WOODLAND LAKES COMMUNITY CHURCH ADDITION

RE: SUB2001-00127 WOODLAND LAKES COMMUNITY CHURCH ADDITION

At the regular meeting of the Subdivision Committee of the Metropolitan Area Planning Commission on Thursday, January 3, the above captioned plat was considered. The action of the Committee was to approve the final plat, subject to the following:

STAFF REPORT
(One-Step Final Plat)

FINAL PLAT

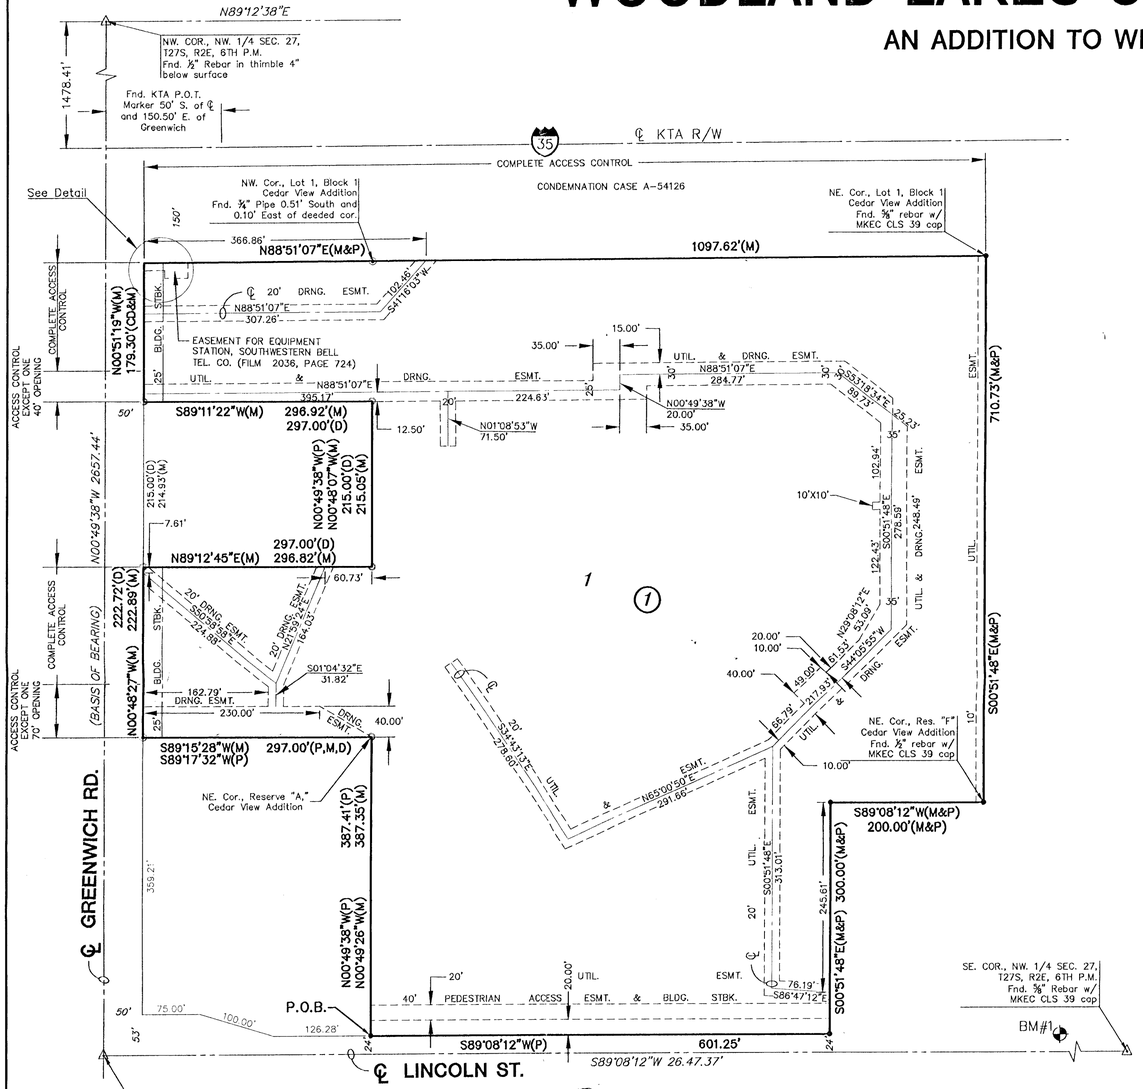
D. **Traffic/County Engineering** needs to comment on the access controls. The plat proposes two access openings along Greenwich. Distances should be shown for all segments of access control. ***Traffic Engineering has required a minimum distance of 400 feet between the openings.***

E. The Applicant is advised that if platted, the building setback along Greenwich must be 35 feet to conform with the Zoning setback standard for County section line roads. (4 City Now)

G. ***Traffic Engineering has requested a petition for a southbound left turn lane.***

P. The representatives from the **utility companies** should be prepared to comment on the need for any additional utility easements to be platted on this property. ***Southwestern Bell has requested the platting of an existing private utility easement.***
